Model 394

Throttle cable

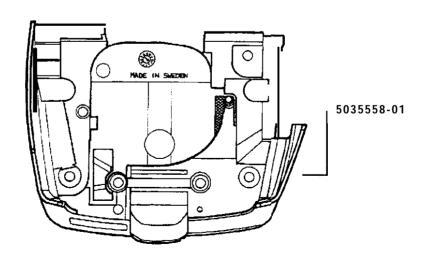
The following improvements are made in order to even more increase the durability:

- New material on the outer cover (the previous was black, today light brown)
- Inside cables covered with plastic
- Cast nipples (the earlier were pressed on)

Saws manufactured earlier than 1993: The bottom of the carburettor area, ref. no. 503 55 58-01 should be modified according to the illustration. At the underside of the bottom, the marked area should be filed (rounded off). This measure prevents that the cable cover wears out.

New Ref. No.DescriptionExcl. Ref. No.503 52 04-02Throttle cable503 52 04-01

Introduced from serial number: 3230292
